Consultation Response from KC, Conservation and Design
2020/94197 78, Wellhouse Green, Golcar, Huddersfield, HD7 4ET
Listed Building Consent for erection of two storey extension to side (within a Conservation Area)
Date Responded: 22/02/21 Responding Officer: Craig McHugh Responding Ref: CV2/267
REVISED
Significance of the heritage assets affected

Photographs dated January 1981

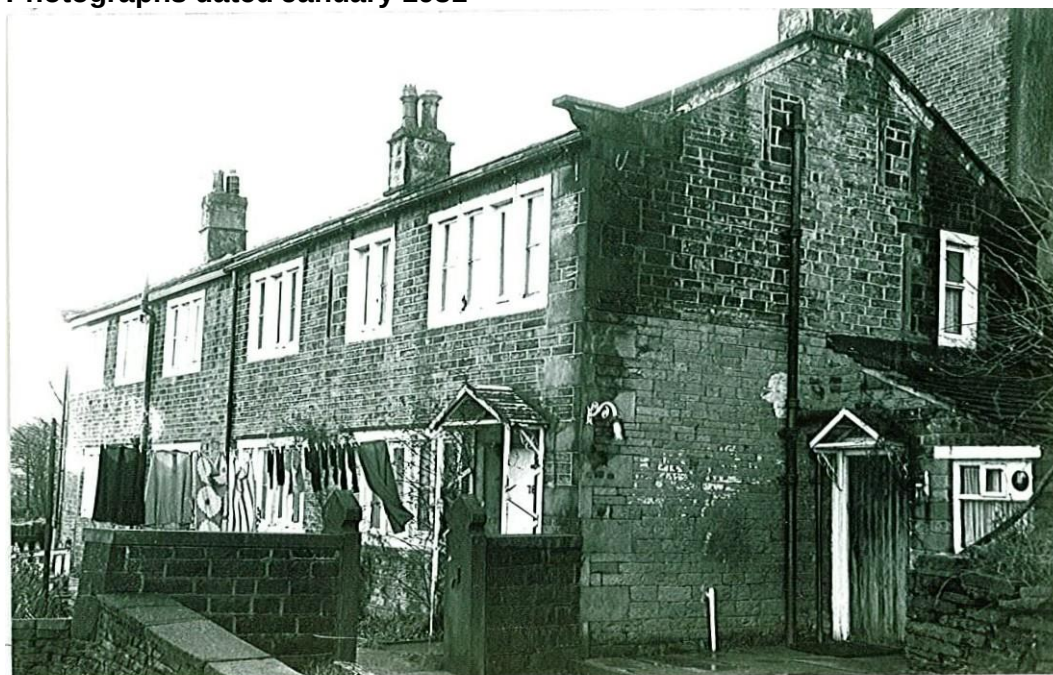
The proposed alterations would result in a large opening being formed at first floor between the existing house and the extension. This is in the vicinity of the chimney breast below (dining kitchen). There is no chimney breast shown at first floor in bedroom 1. However, photographs from around the time of listing show that the building previously had a chimney stack (now truncated without listed building consent) likely sufficient to serve two fireplaces.
